## CITY OF ALBUQUERQUE

RE: Unser & Vista Oriente Shell Building, Lot 1-B-3, Ladera Industrial Center, Unser Boulevard
Grading and Drainage Plan
Engineer's Stamp Date 5-19-2015 (File: H10-D006A5)

CG-102

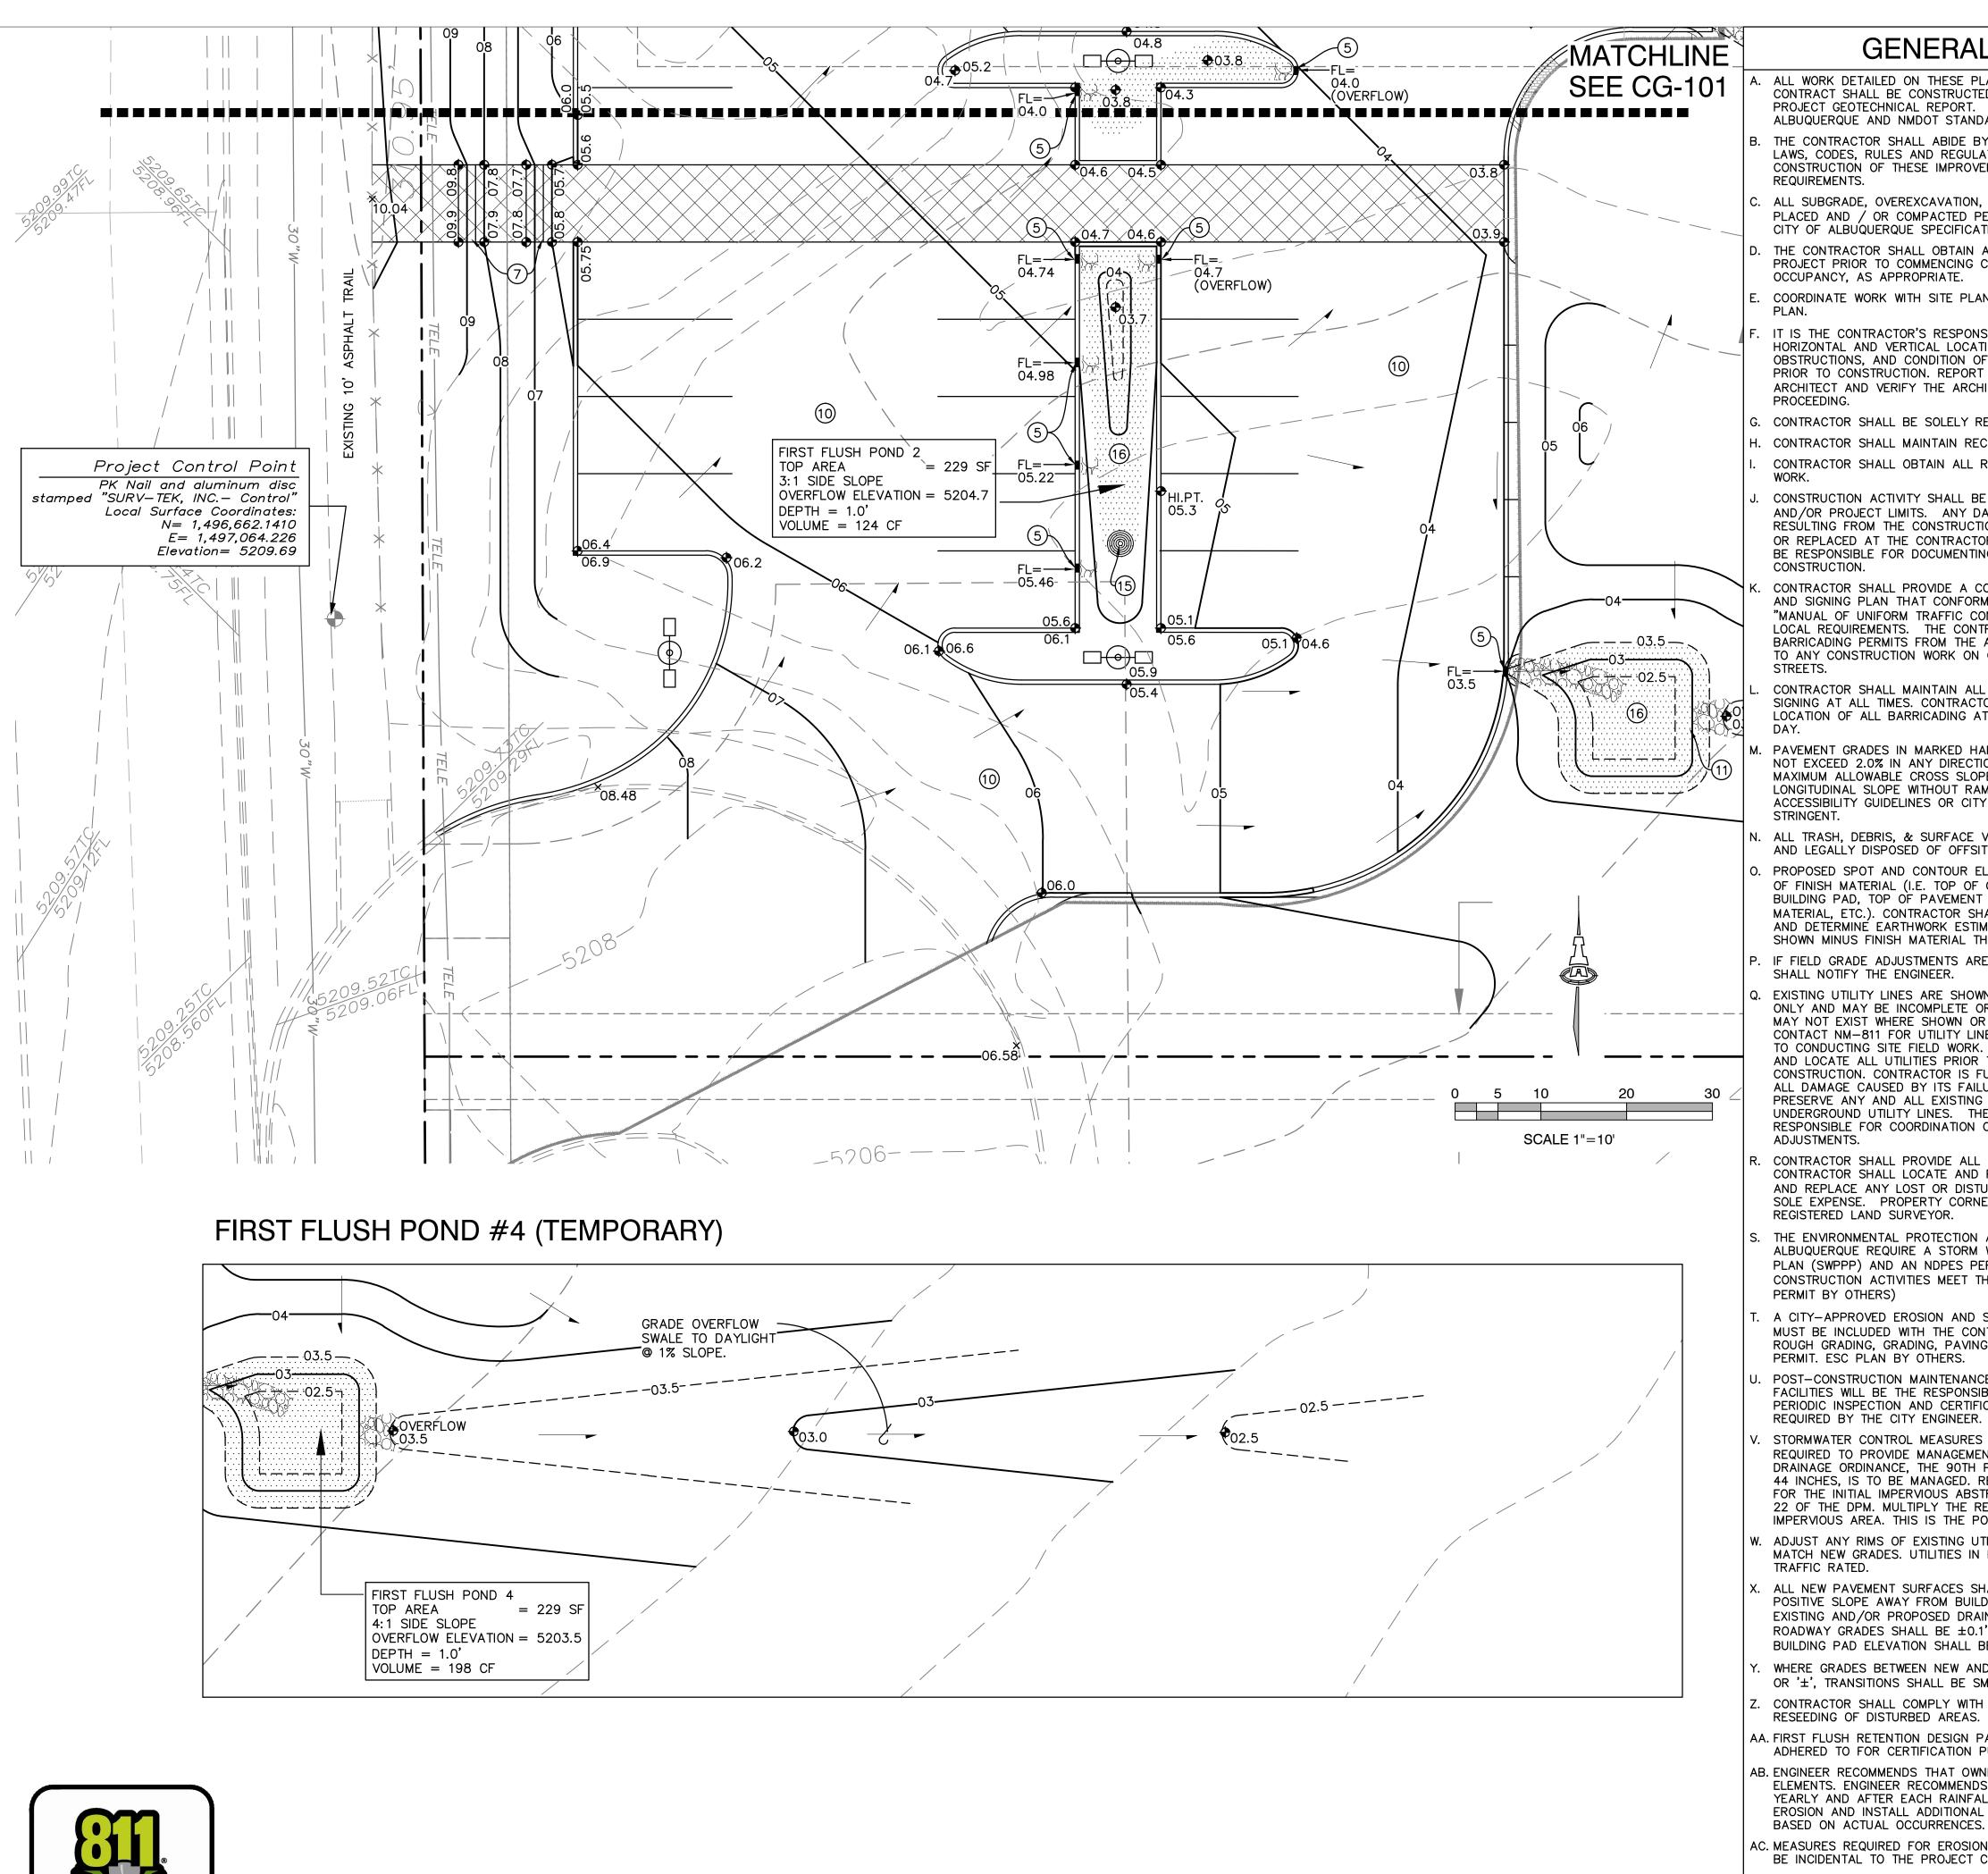
2) A couple of the new spot elevations were cut off on the right side of the plan view on Sheet CG-102.

CG-501

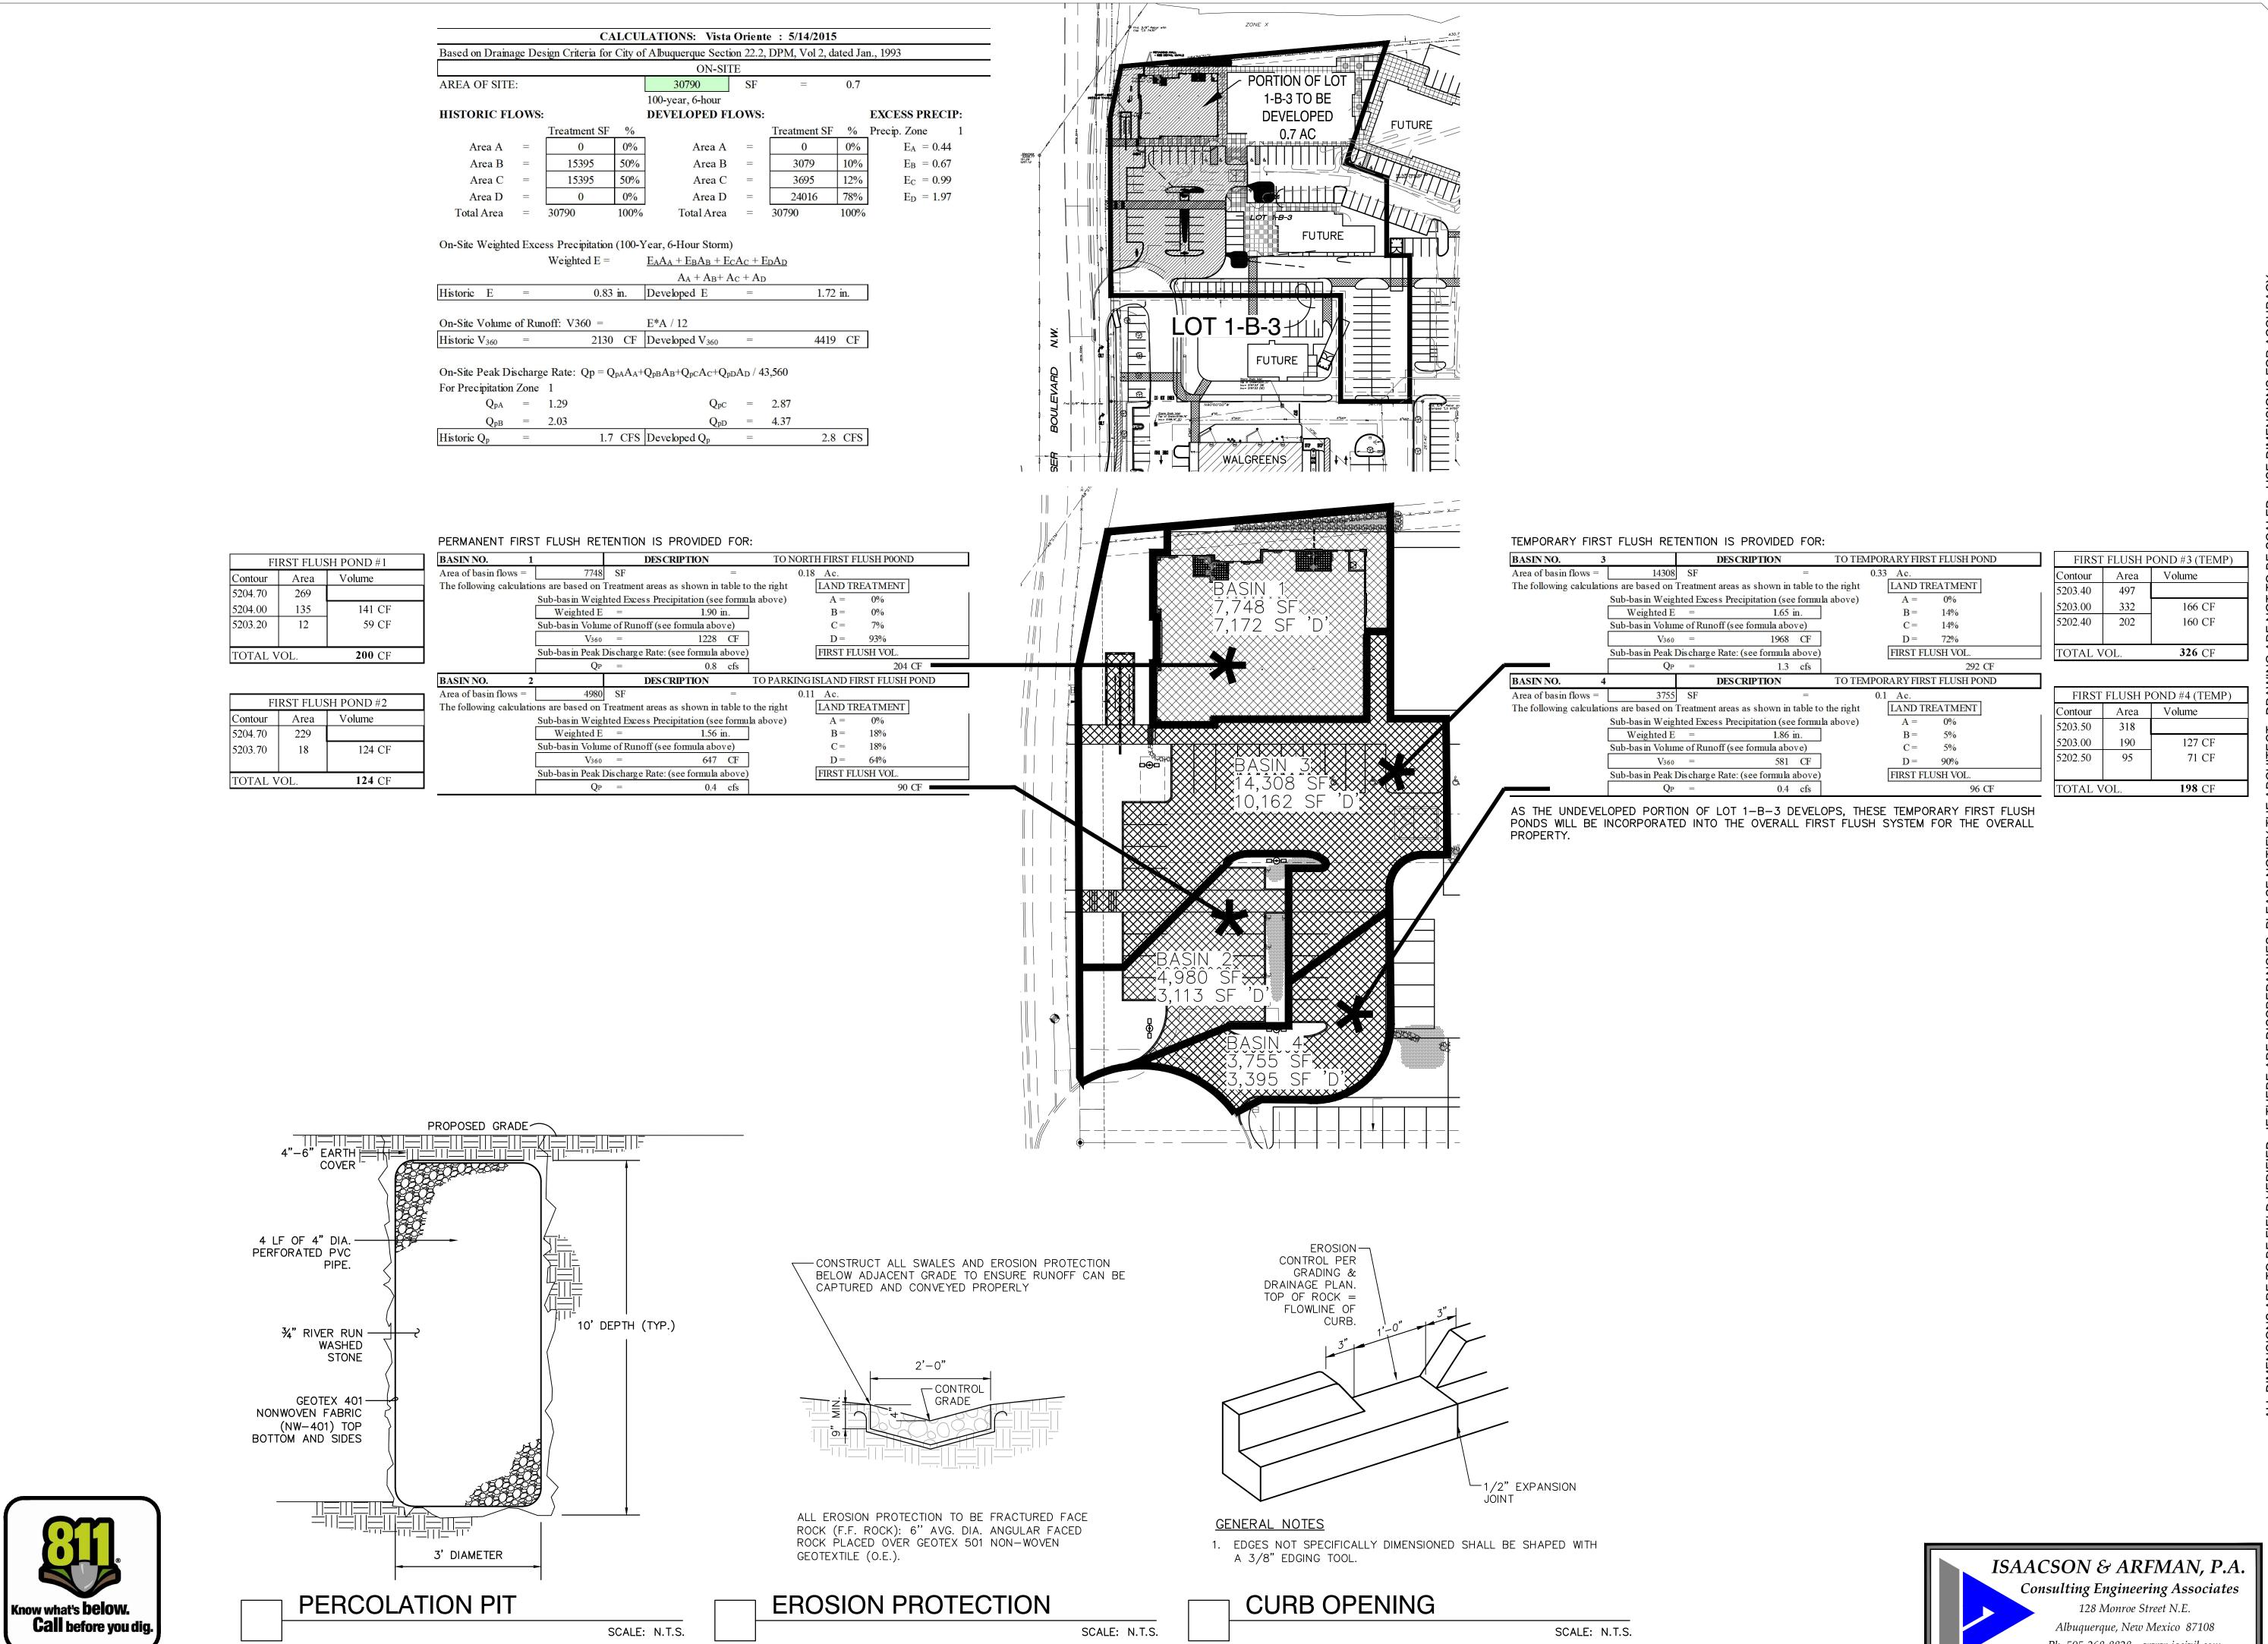
3) For Basin 3 on Sheet CG-501, the labeling of the basin area on the plan view needs to match the basin area in the calculations. Also, label lot line for Lot 1-B-3.
